ADDENDUM NO. 2

PROJECT NAME: **CESAR CHAVEZ PARK PERIMETER PATHWAY
IMPROVEMENT PROJECT**

SPECIFICATION NO.: **25-11702-C**

DATE: **APRIL 10th, 2025**

CESAR CHAVEZ PARK PERIMETER PATHWAY IMPROVEMENT PROJECT
METHANE GAS COLLECTION SYSTEM
 SHEET No. **MS-1**
 TOTAL SHEETS: 21
 FILE No.: SCC-22-155
 SCALE:

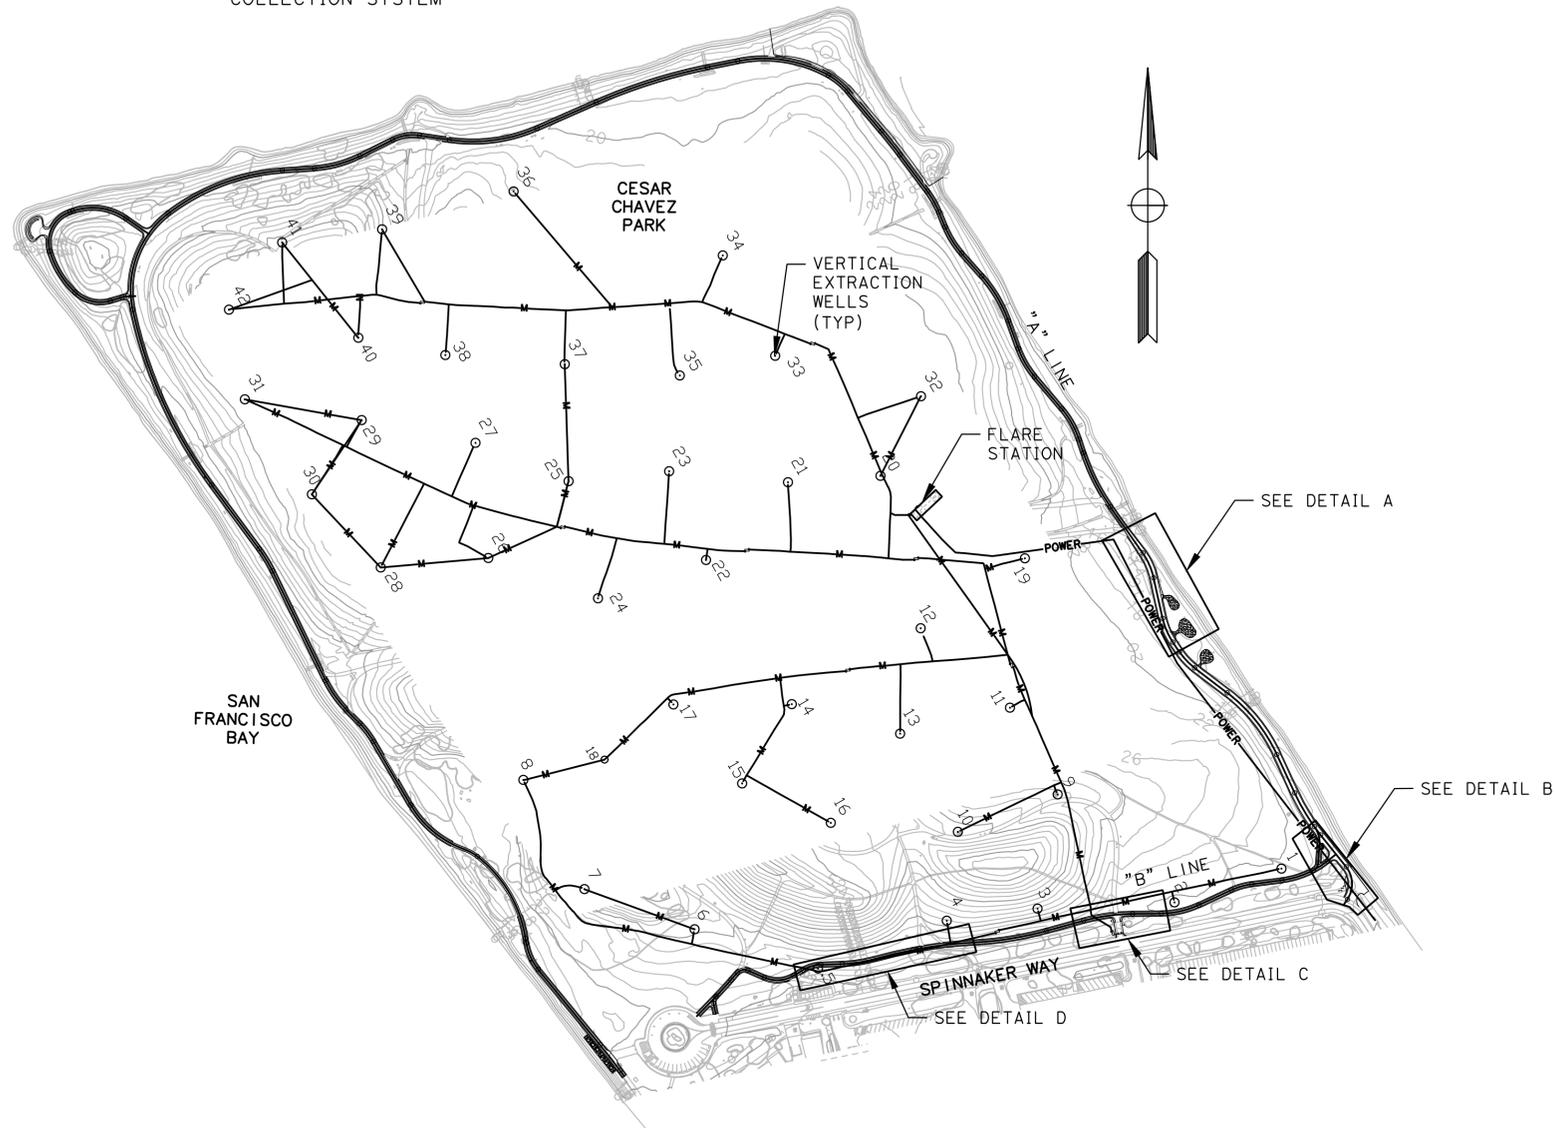
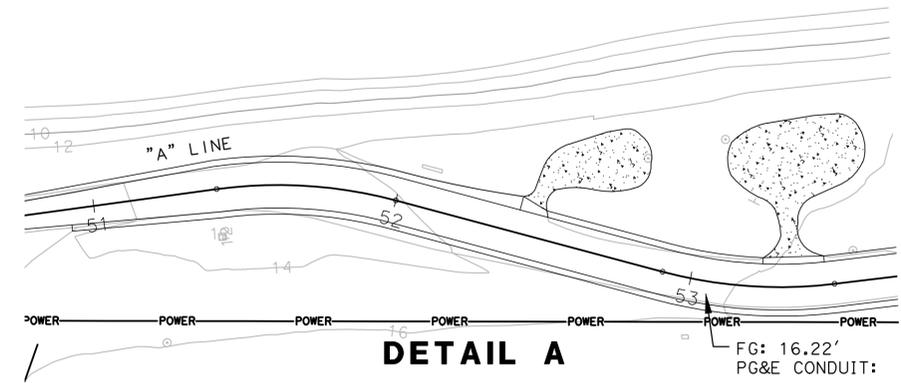
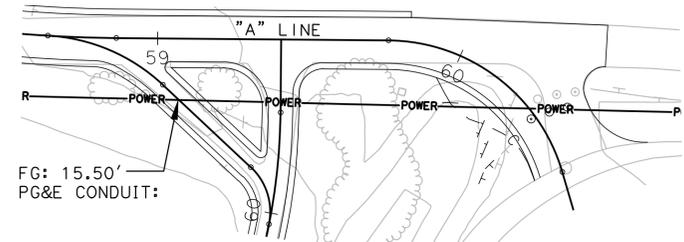
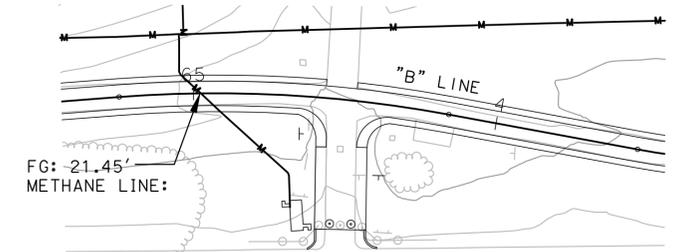
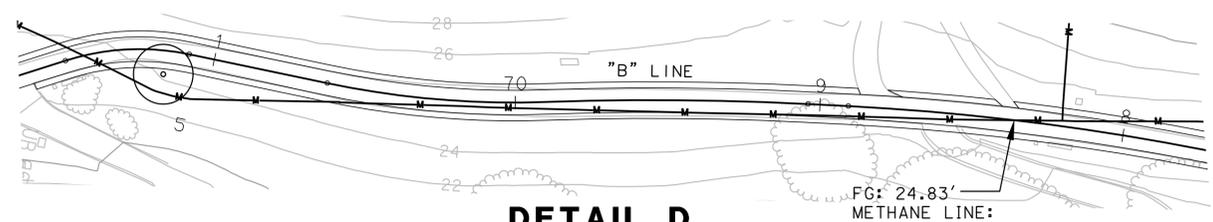
5. **Plans:** Cesar Chavez Pathway Improvement Project – Final Plans.
ADD Sheet MS-1 Methane Gas Collection System Sheet to Plans.
6. **Specifications:**
REPLACE Bid Opening Date and Time to 2:00 PM, THURSDAY, APRIL 17th, 2025.
REPLACE Pre-award Conference Date and Time to 2:00 PM THURSDAY, MAY 1st, 2025.
7. **Specifications:** Bidders Proposal
REPLACE with attached Revised Bidder’s Proposal – Addendum 2.
8. **Specifications:** Part C – Technical Specifications
